CITY COUNCIL AGENDA ITEM

Subject: PUBLIC HEARING – PRELIMINARY SITE PLAN REVIEW (SP JPLN2021-0028) - Proposed Golden Villas One Family Residential Cluster, South side of Square Lake, West of Dequindre (PIN 88-20-12-200-031 & 88-20-12-200-035), Section 12, Currently Zoned R-1C (One Family Residential) District

Preliminary Site Condominium Cluster Review For City of Troy, Michigan

Project Name:	Golden Villas
Plan Date:	February 28, 2022
Location:	South of E. Square Lake, west of Dequindre
Zoning:	R-1C, One-family Residential District
Action Requested:	Preliminary Site Condominium Cluster Approval
Required Information:	Deficiencies noted.

FRONT ELEVATION
SCALE: 1/4" = 1'-0"
B

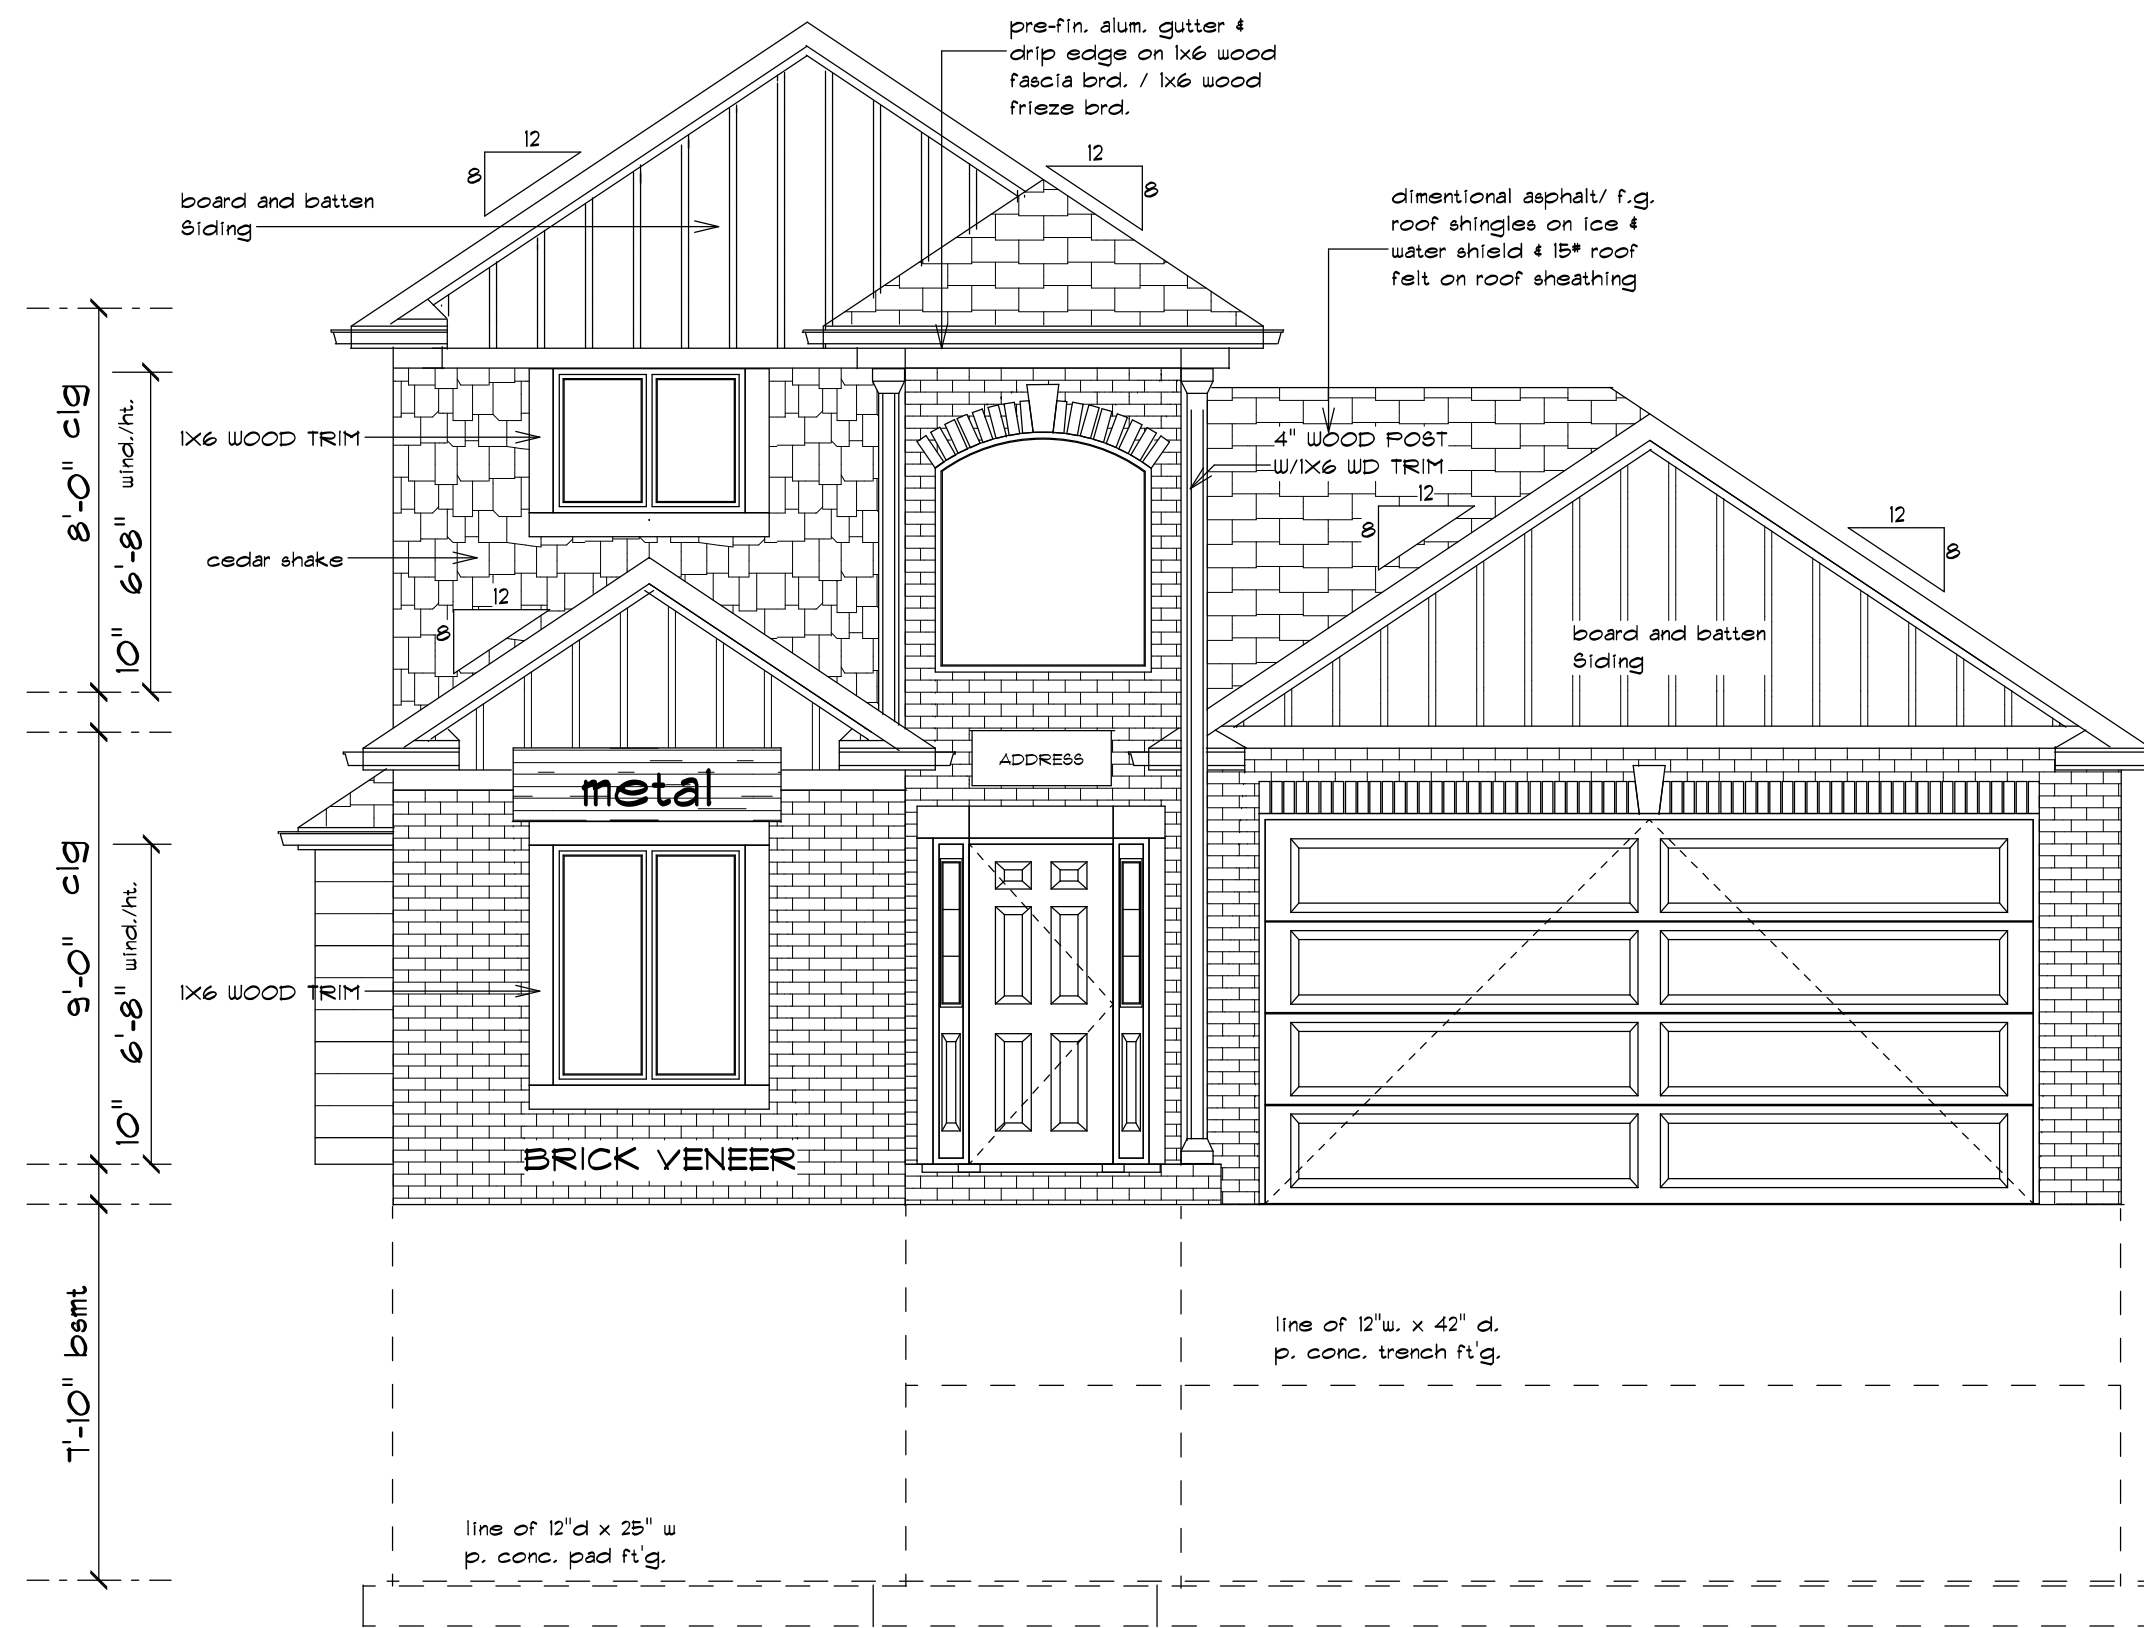
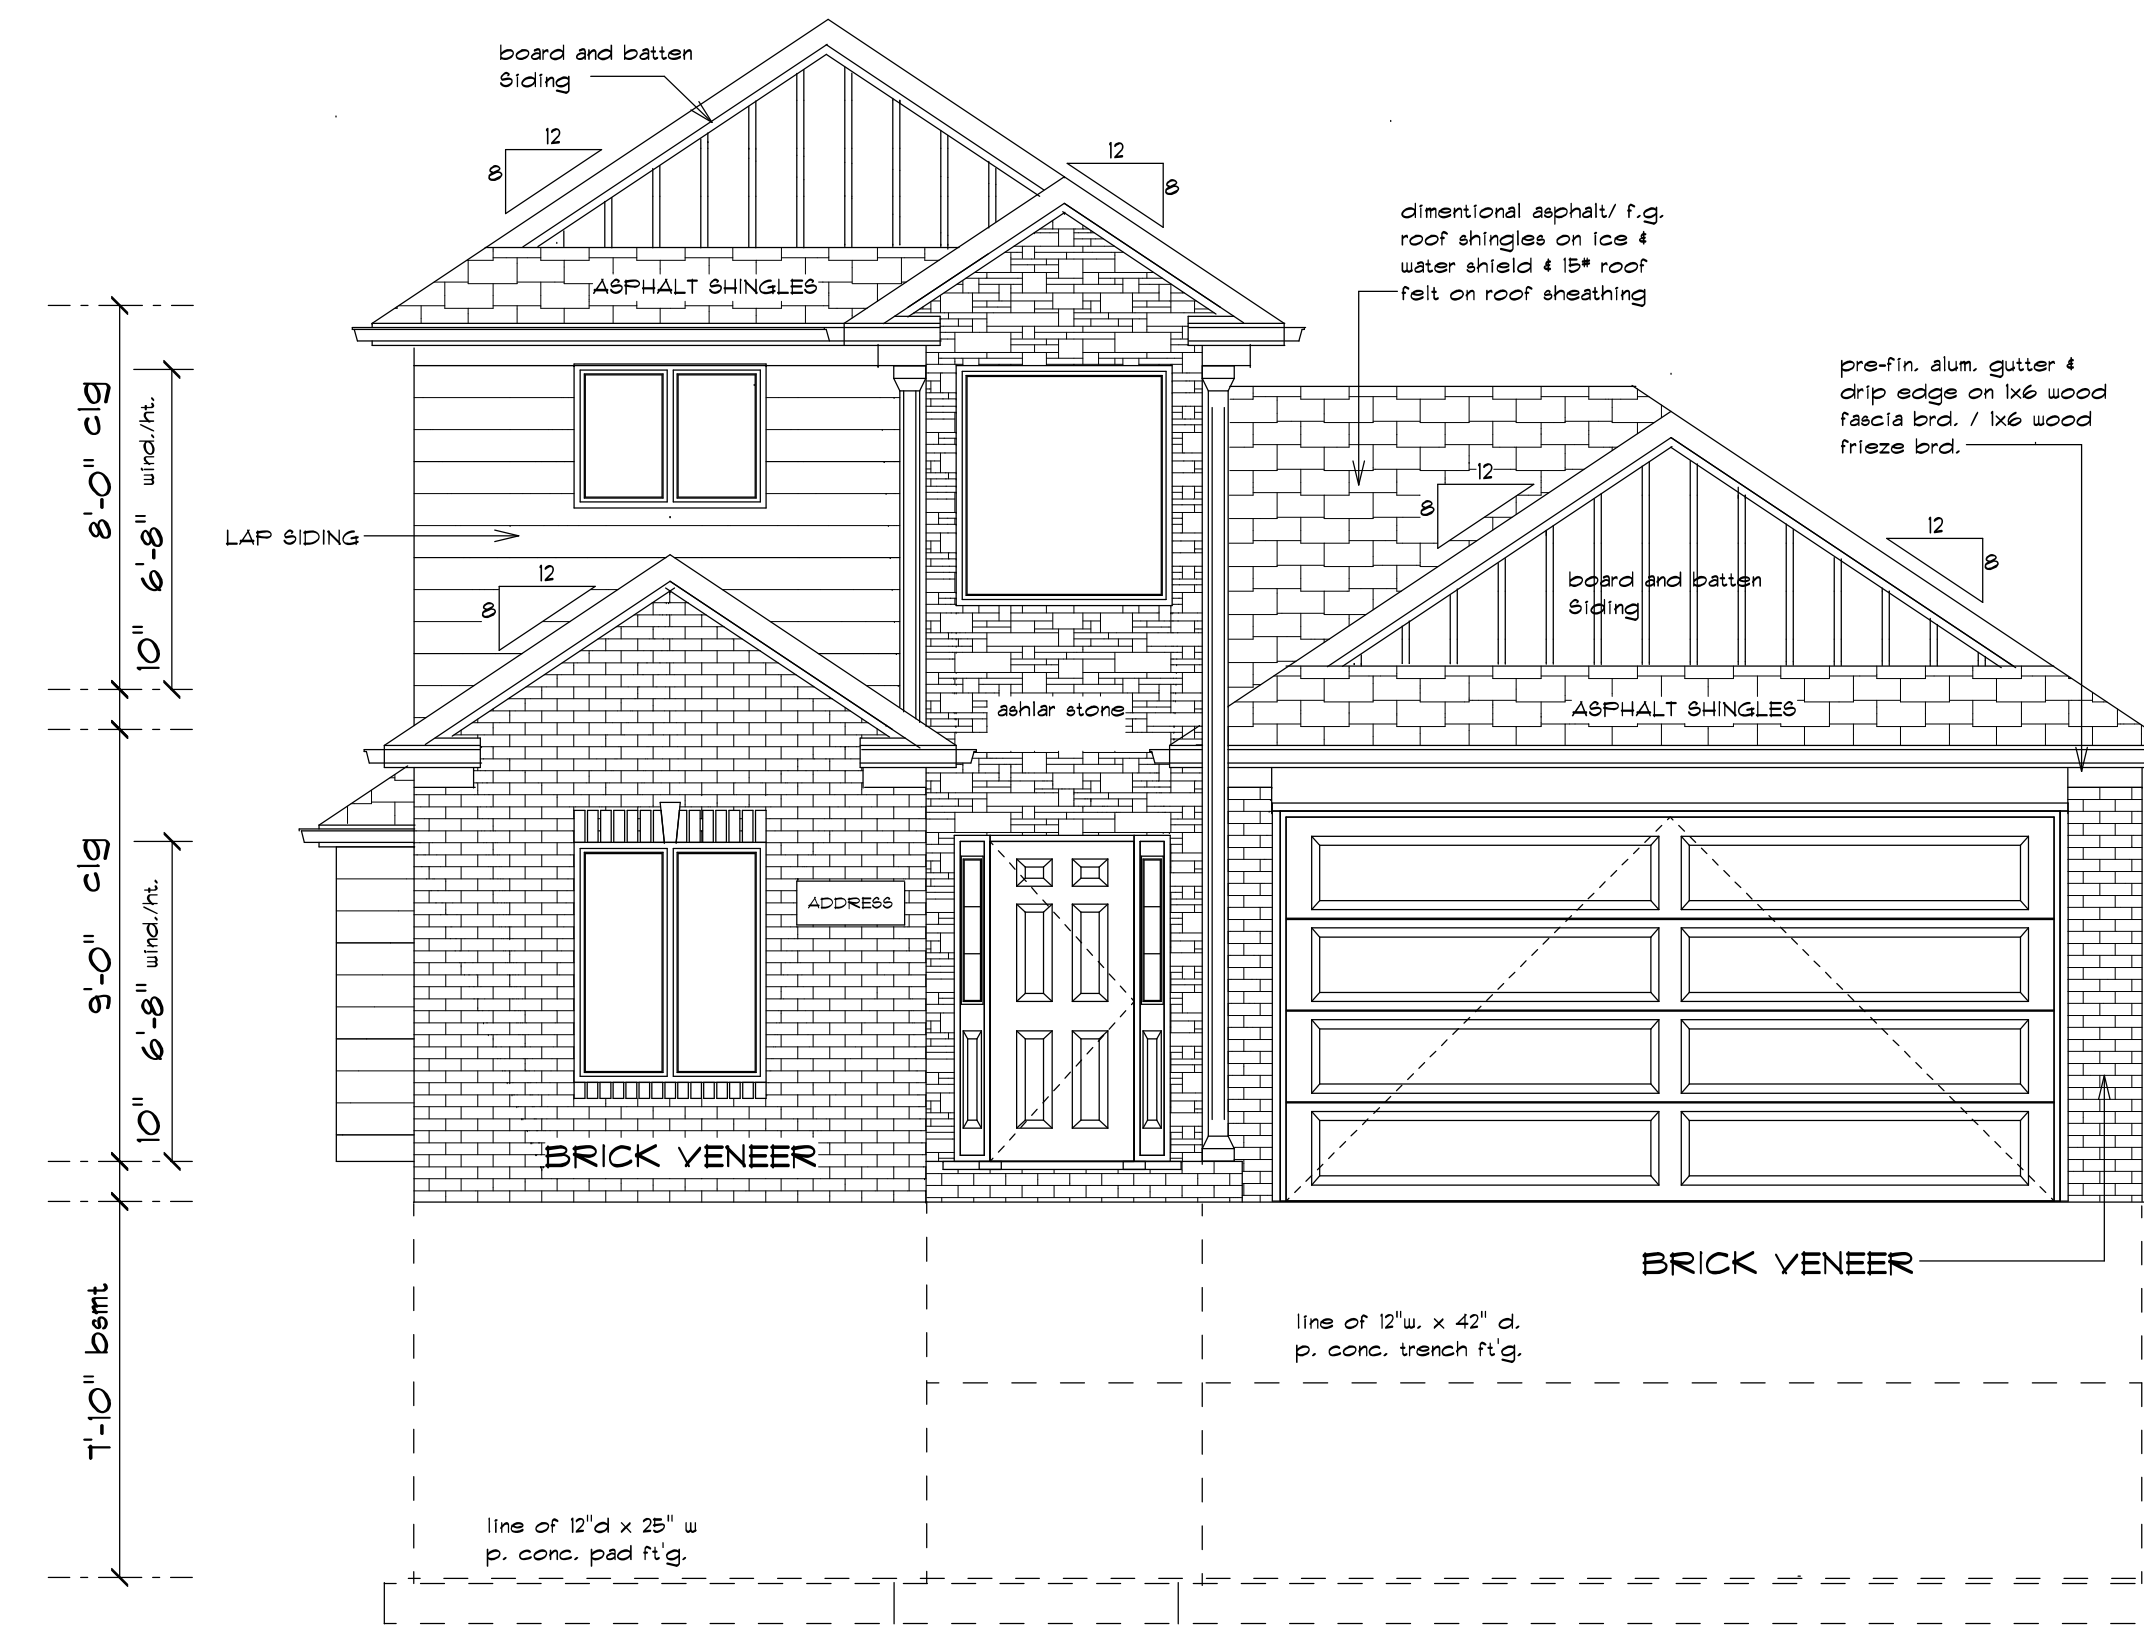
The applicant has submitted one housing options with a square footage up to 1,900. The applicant shall supply additional housing elevation options. Materials include brick, stone, and cedar veneer.

Items to be Addressed: Provide additional housing elevation options

The petitioner submitted a Landscape Plan with the additional twenty (20) trees along Square Lake Road. The petitioner has provided numerous additional housing elevation options which were included with the site plan. The petitioner has agreed that the exterior elevations will not include vinyl siding. An Open Space Preservation Agreement will be required to be submitted and approved prior to Final Site Plan Approval.
